**To: Belfast Planning Board**

**From: Upstream Watch Consultants**

**RE: Response to Ms Olver October 10, 2020 Report:  
Nordic Aqua Farms Waste Water Discharge Review**

**Date: October 15, 2020**

Exhibit 1 Asymptotic steady state predictions of time series areal dilution at the environmentally sensitive region containing diluted effluent with the median age of 1.5 – 2.5 days old. The  $10^{2.5}$  line represents ~300:1 dilution for the Green 50<sup>th</sup> percentile.

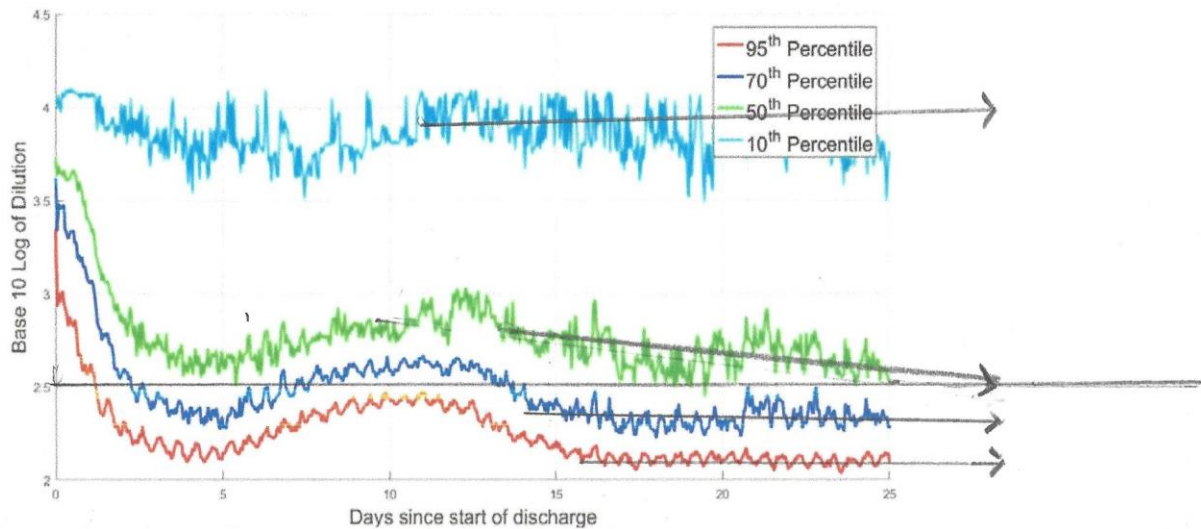
2. The point of using these models of different percentages of the areas with predicted dilution is to view what the longer-term equilibrium value will be. The 25-day model for the different area percentage to reach equilibrium suggests that the lower dilutions tend to be reaching equilibrium (or a more steady state) at less than 50%. The 70% line (meaning 30% of the area will have a dilution less 160:1) is clearly showing a leveling out by 25 days.

3. To arbitrarily pick a fortnight of time that includes a tidal variation (high and low tides and tidal wave interference) before equilibrium is being reached in Figure 2 is cherry picking of data in an attempt to provide a desired result. Indeed, the way that Dill and others have originally referenced their Exhibit 23 was the statistical way to predict a steady state longer term dilution for a certain location over time. It is the end time that we seek, not the times of tidal oscillations before equilibrium is modeled. Depicted below as Exhibit 1 is a markup of Dill's Figure 2. Here, the approximate asymptotes of the data for each of the represented % areas are penciled in. The asymptote line represents the predicted end point of the final dilution value beyond the 25.45 days when the dilution has reached a more steady state equilibrium. Nordic has now suggested to use instead a cherry picked portion of the graph with a higher dilution than the steady state longer value.
